Customer : CU-DAR001 Dart Helicopters Services	Drawing Name : BASKET RIB
Job Number : 45780	
Estimate Number : 10404	
P.O. Number :	Part Number : D31663
This Issue : 13/02/2009 S.O. No. :	Drawing Number : D3166 REV A2
Prsht Rev. : NC	Project Number : N/A
First Issue : / / Type : LARGE FAB ASSY	Drawing Revision : A2
Previous Run : 44997	Material :
Written By :	Due Date : 17/02/2009 Qty: 3 Um: Each
Checked & Approved By :	
Comment : Est. A 02.08.23 New issue KJ Est Rev:B 09-01-23 as per DEO D3166-A2 DD verified by:EC

DRAWING NO. D3166	TITLE BASKET HOOP	REV.A1	DART AEROSPACE LTD ENGINEERING ORDER		D.E.O. NO. D3166-A-2	SHEET NO. 1 OF 1	SCALE NTS
DRAWN AJS	CHECKED 1	MFG. APPR. M	APPROVED MD		DE APPR. H		
DATE 08.12.11	DATE 08.12.15	DATE 08/12/15	DATE 08/12/16		DATE 08.12.16

DESIGN #	DRAWN BY CP	DART AEROSPACE LTD HAWKESBURY, ONTARIO, CANADA	
CHECKED #	APPROVED #	DRAWING NO. D3166	REV. A SHEET 1 OF 1
DATE 02.07.10		TITLE BASKET HOOP	SCALE NTS
A	02.07.10	NEW ISSUE	
11	04.04.08	38 +/- 1 mm 36.0

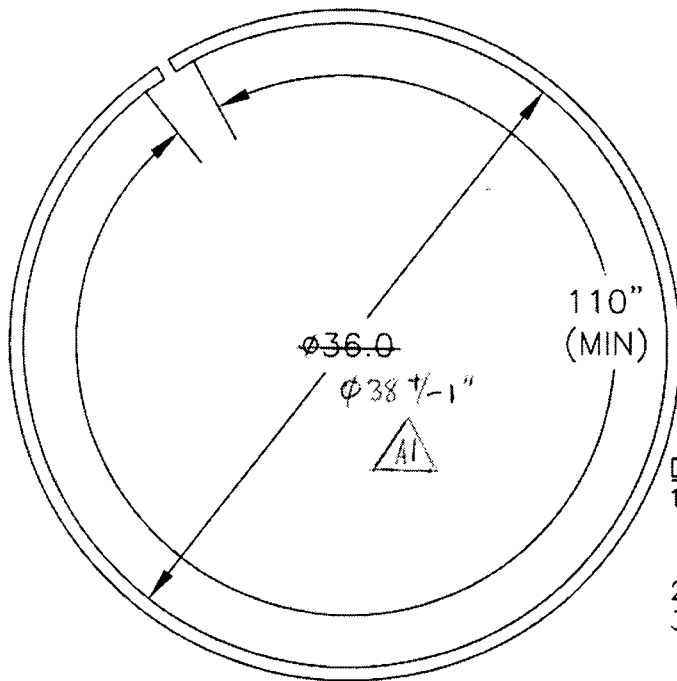
1) MODIFY MATERIAL NOTE FOR D3166-1 AS SHOWN:

WAS:

1) MATERIAL: AISI 304/316 SS SQUARE TUBING,
0.75" x 0.75" x 0.063 WALL, 60.00" LONG
(REF DART SPEC. M304TS0.750W.063)

2) MODIFY MATERIAL NOTE FOR D3166-3 AS SHOWN:

WAS:

1) MATERIAL: AISI 304/316 SS SQUARE TUBING,
0.75" x 0.75" x 0.063 WALL, 120.00" LONG
(REF DART SPEC. M304TS0.750W.063)

REASON: SEE PAR 08-005

IS:

1) MATERIAL: AISI 304/316 SS, 3/4 X 3/4 X 0.065 WALL SQUARE TUBING,
60.00" LONG
REF. DART SPEC M304TS0.750W.065

IS:

1) MATERIAL: AISI 304/316 SS, 3/4 X 3/4 X 0.065 WALL SQUARE TUBING,
120.00" LONG
REF. DART SPEC M304TS0.750W.065
